RPRC DETERMINATION LETTER

Project Description: New construction

Street Location: 4 LEDGEWOOD PL

RPRC DECISION: RPRC - Requires Planning Board

L-701

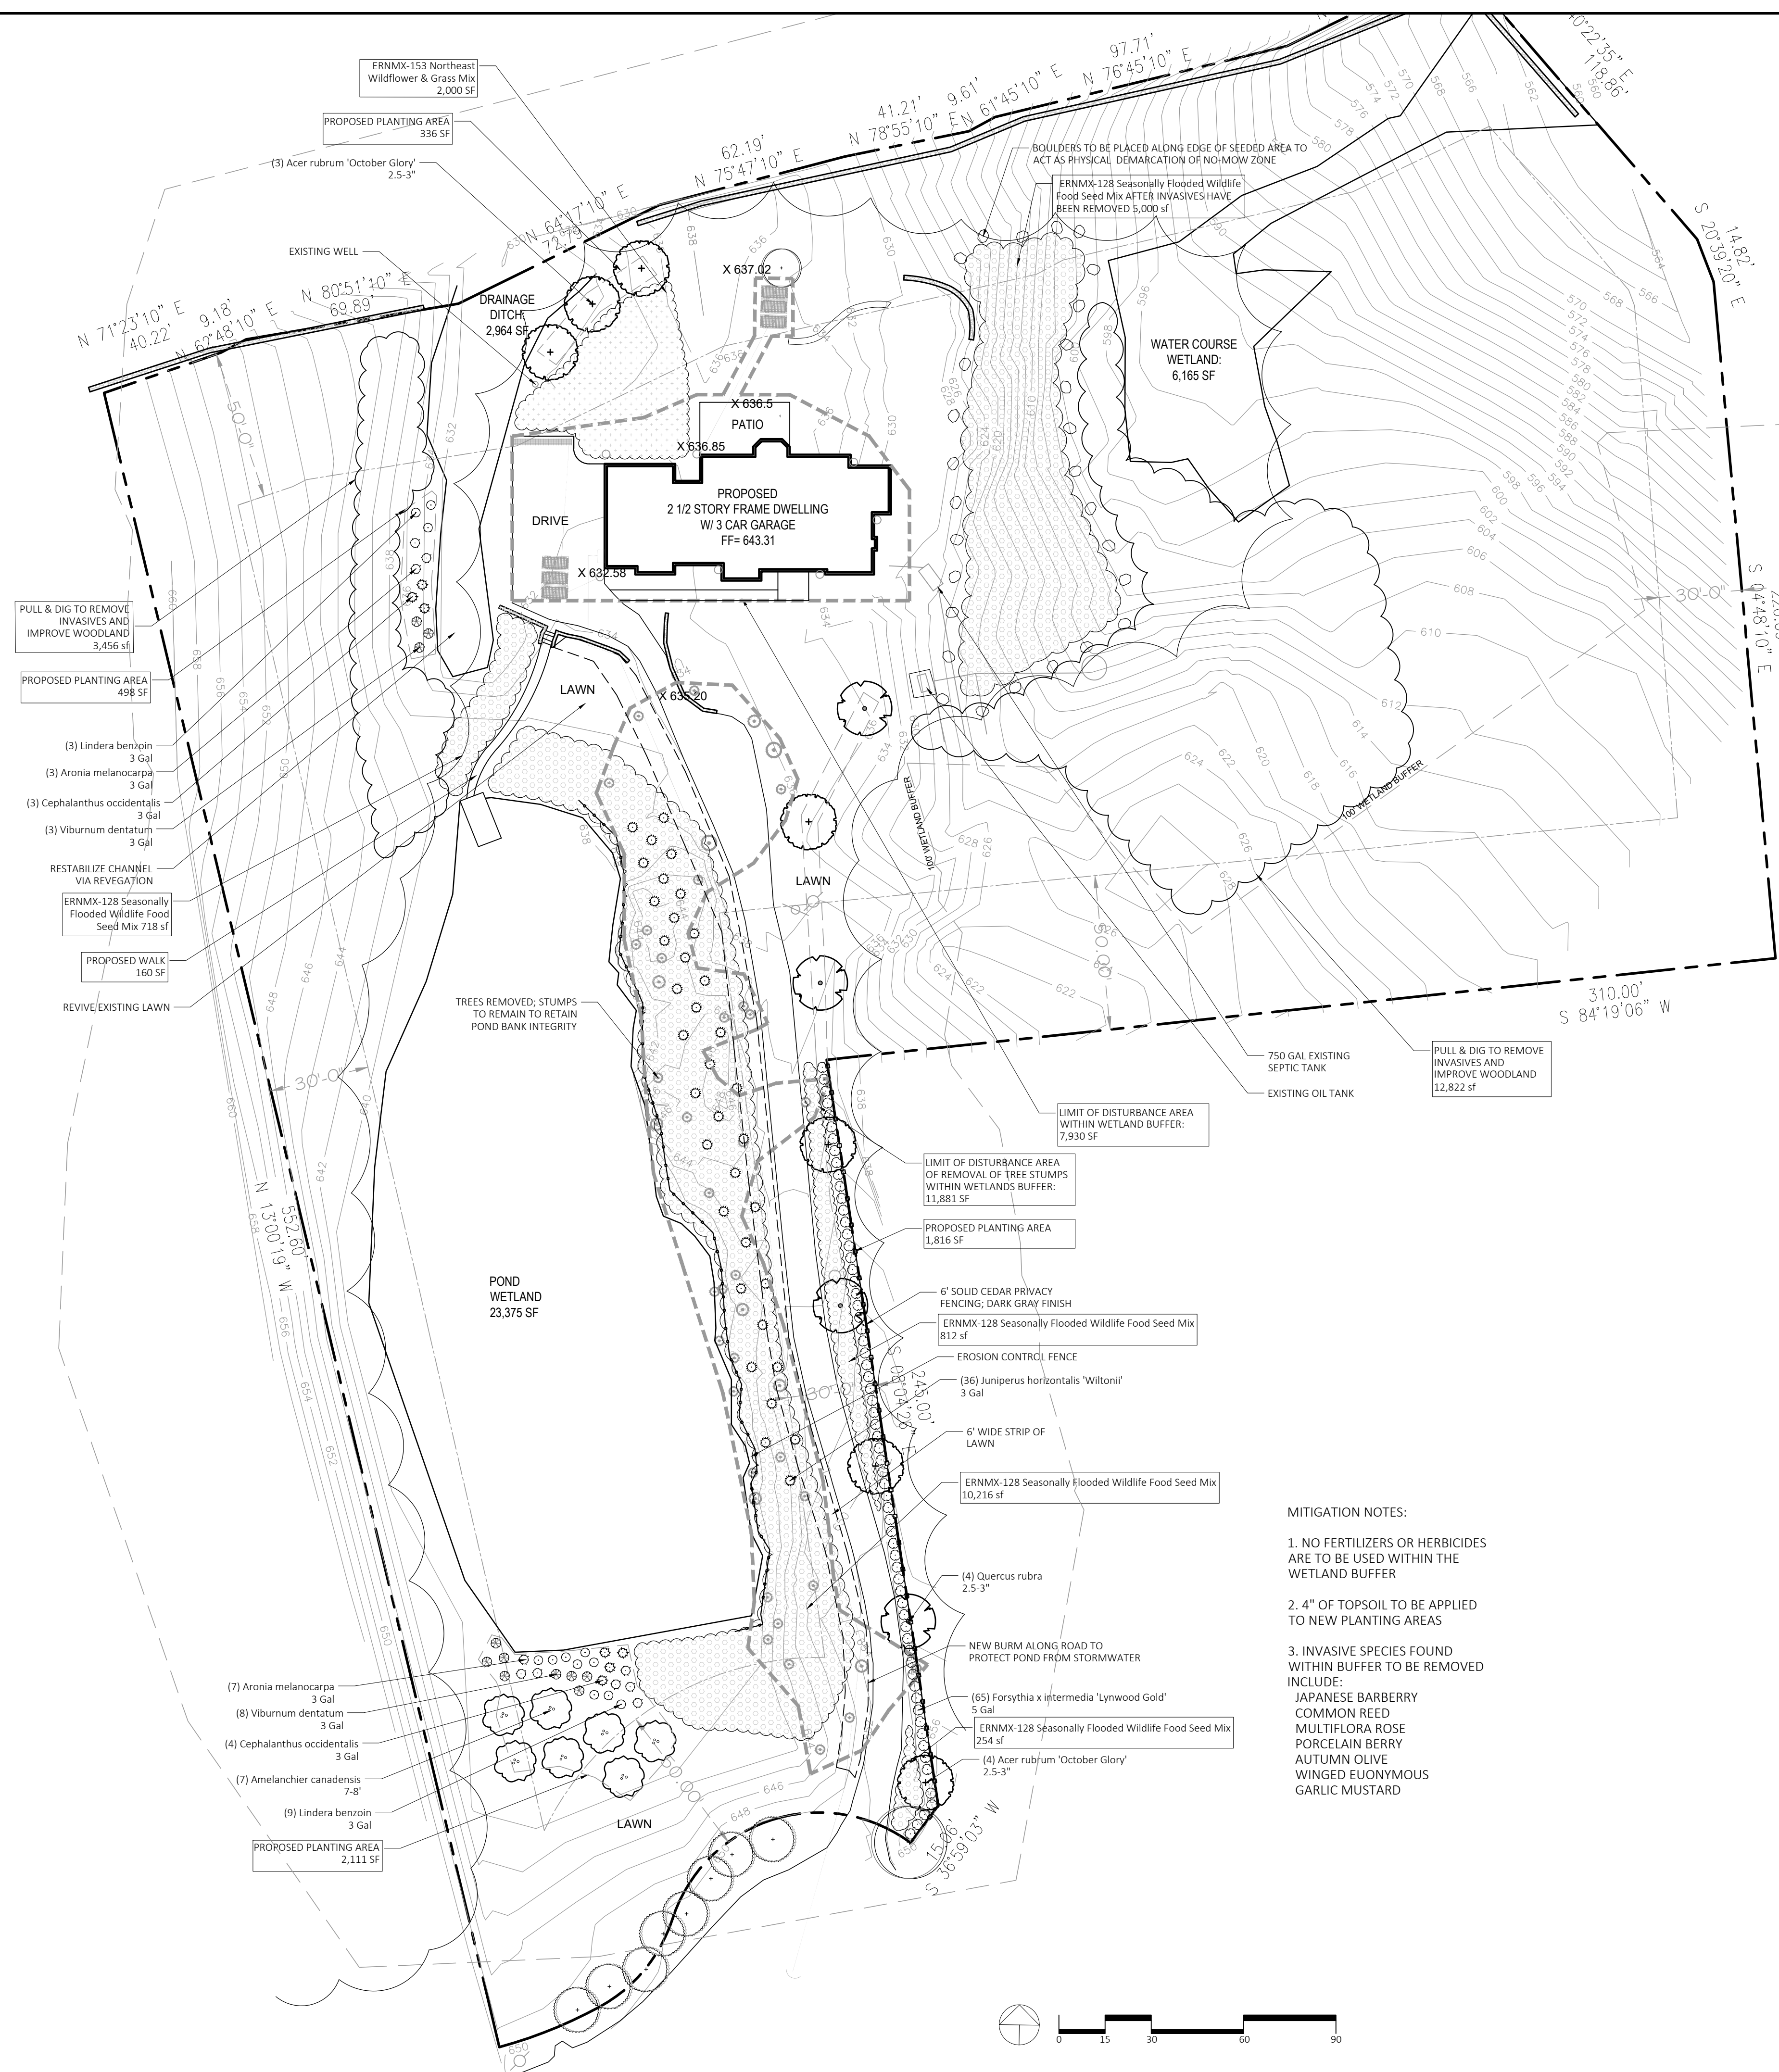
- Plan L-701 states 19,878 sq. ft. of wetland disturbance is proposed. However, it appears that this information may not be correct and represents wetland buffer disturbance. The Applicant should confirm.

- The wetland buffer impact chart also states that disturbance is required for tree removal. Based upon the plan, it appears that the disturbance is proposed for tree stump removal, and not live tree removal. If so, please clarify on plan. Any Town-regulated tree removal should be depicted on the plan and quantified in the chart referenced above.
